Final Drainage Report – Filing No. 1

Waterview East Commercial El Paso County, Colorado

Kimley-Horn and Associates, Inc.

Prepared: July 16, 2026

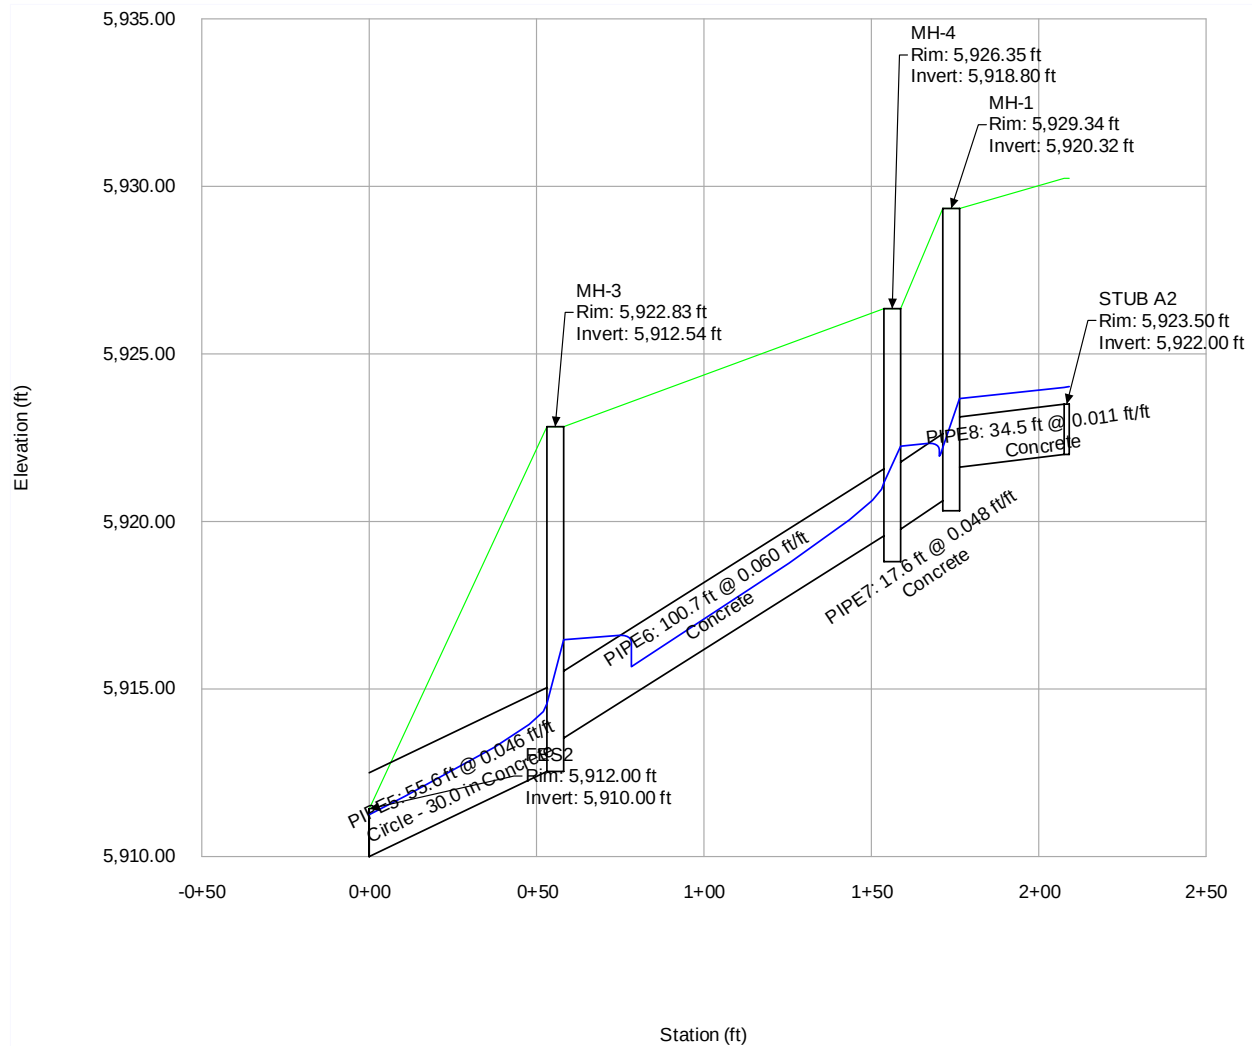
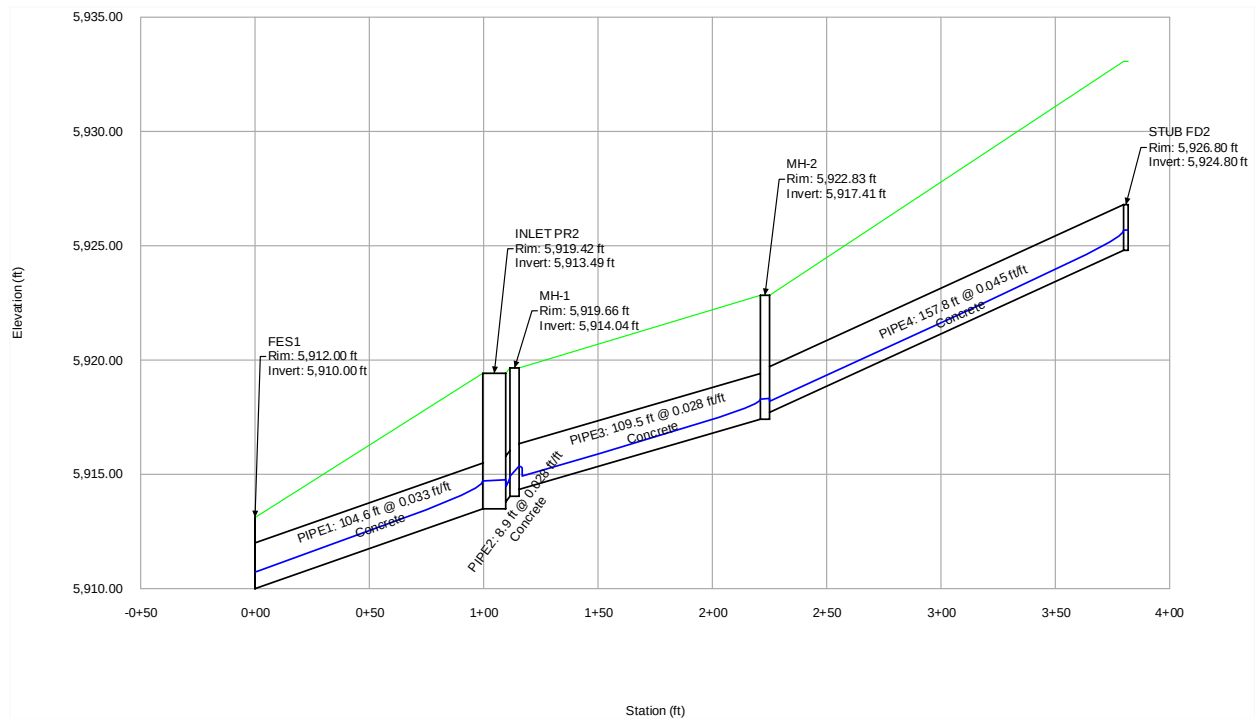
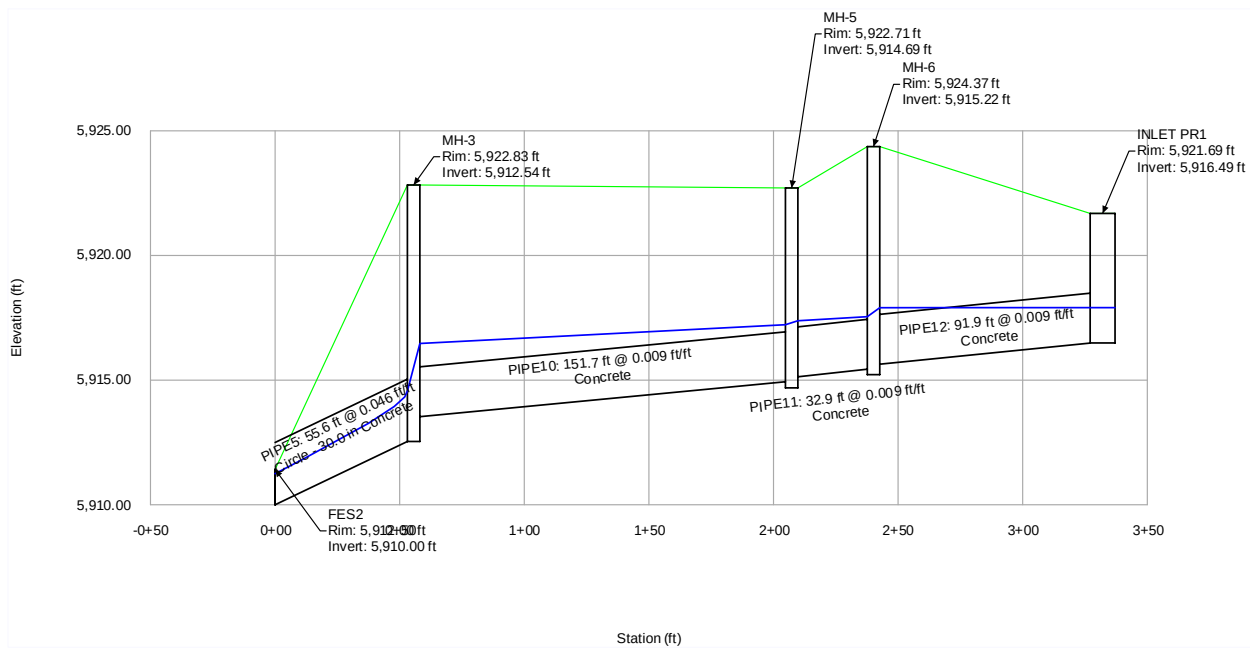
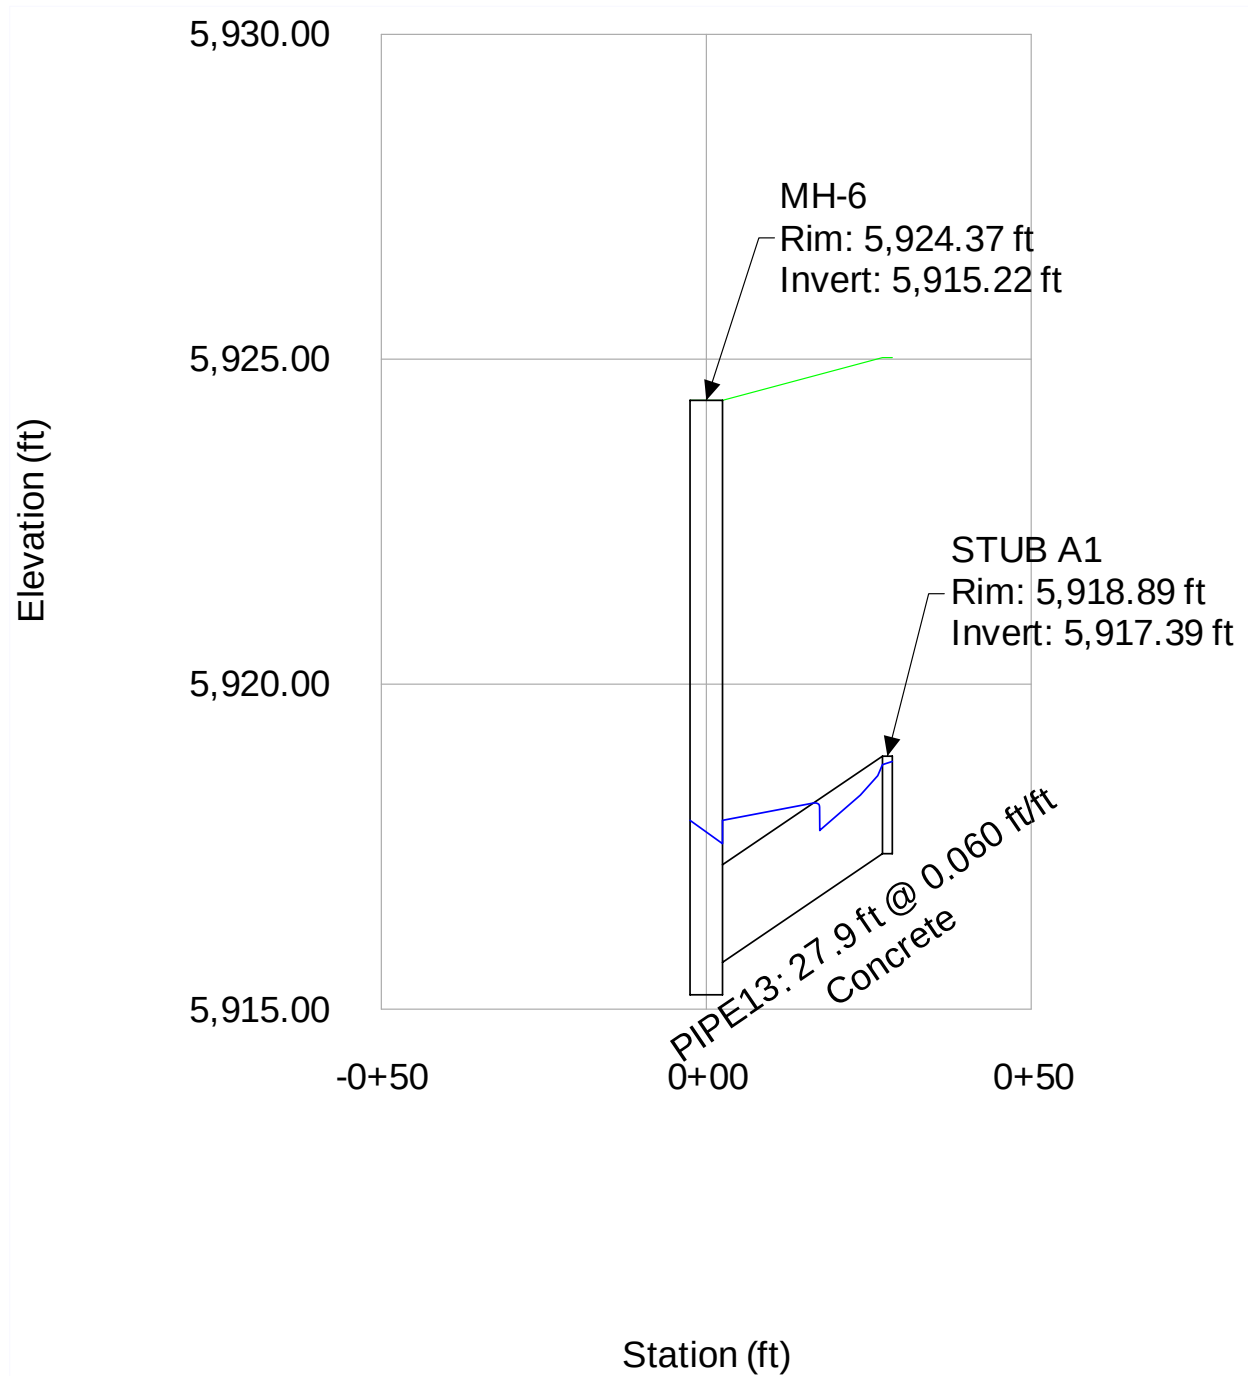
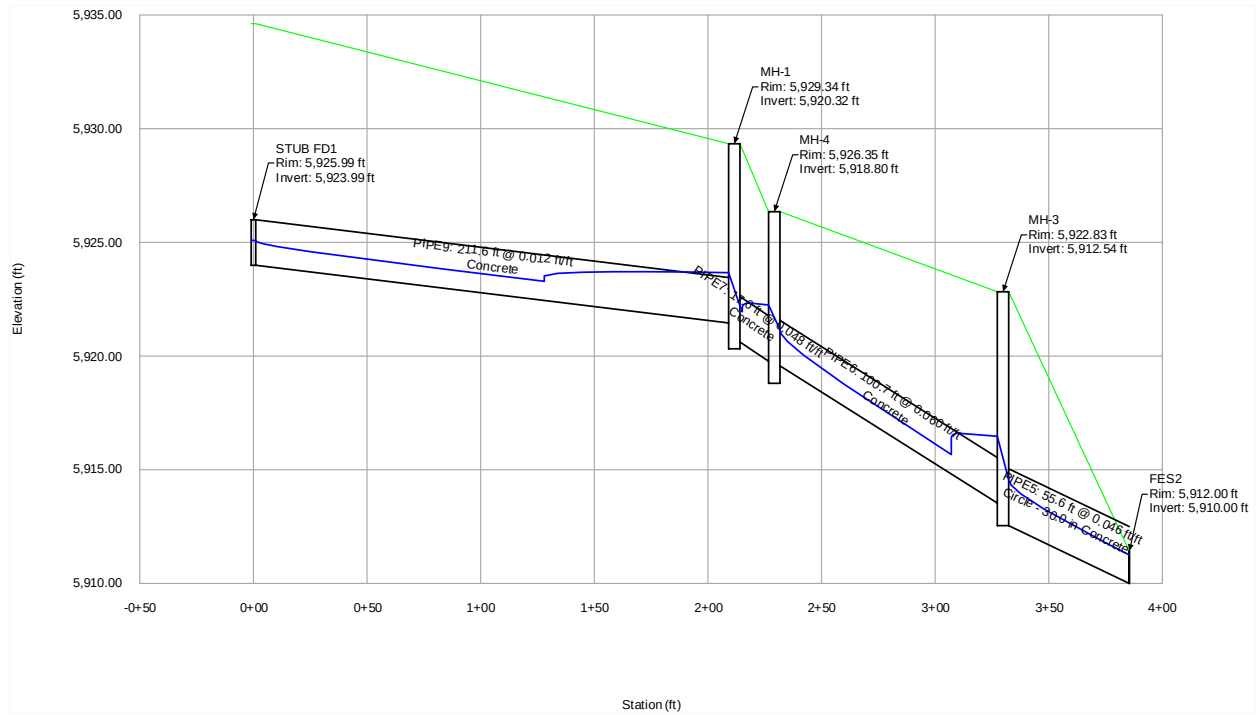
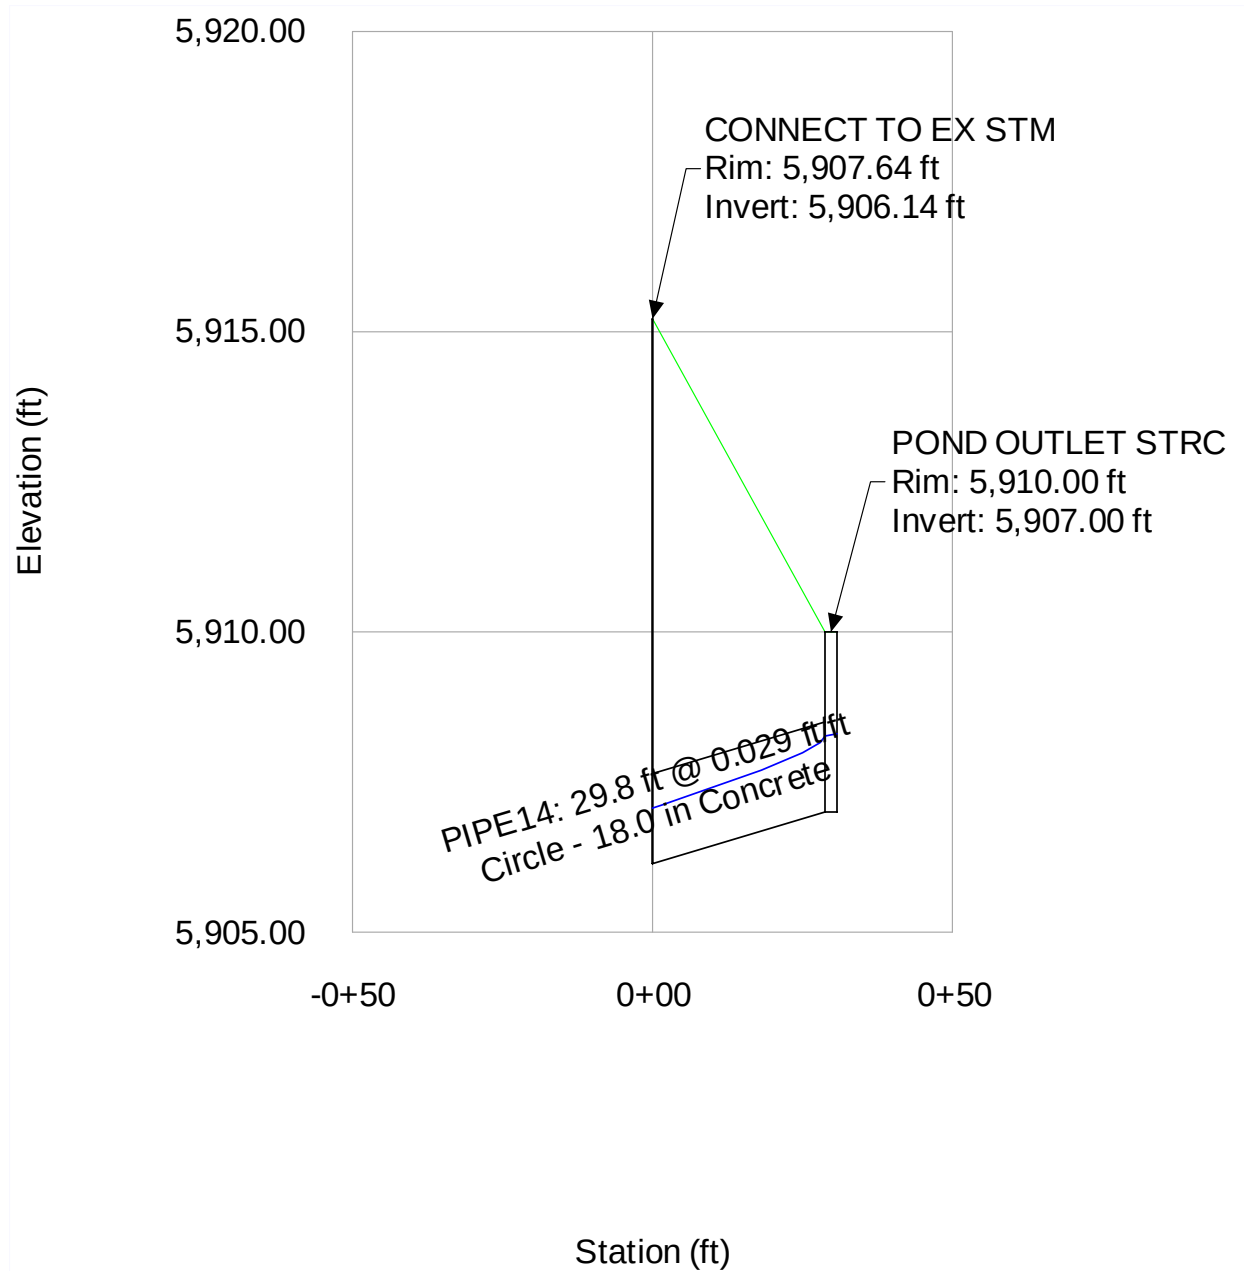
Highlighted values do not match what is shown on the storm plan and profile sheets in the construction drawing plan set (Sheets C4.11-C4.14). Please review and revise.

Highlighted values do not match what is shown on the storm plan and profile sheets in the construction drawing plan set (Sheets C4.11-C4.14). Please review and revise.

KH Response:
Values updated to match what is shown in plans

KH Response:
Values updated to match what is shown in plans

APPENDIX F – DRAINAGE EXHIBITS

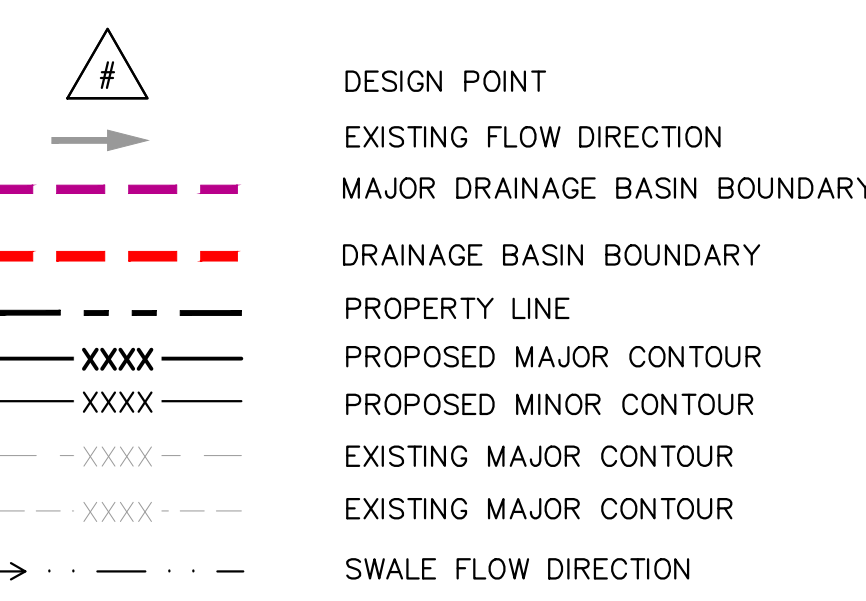
Please show paths chosen for computation of time of concentration on Existing Drainage Map and Proposed Drainage Map.

KH Response:
Paths shown and
labeled
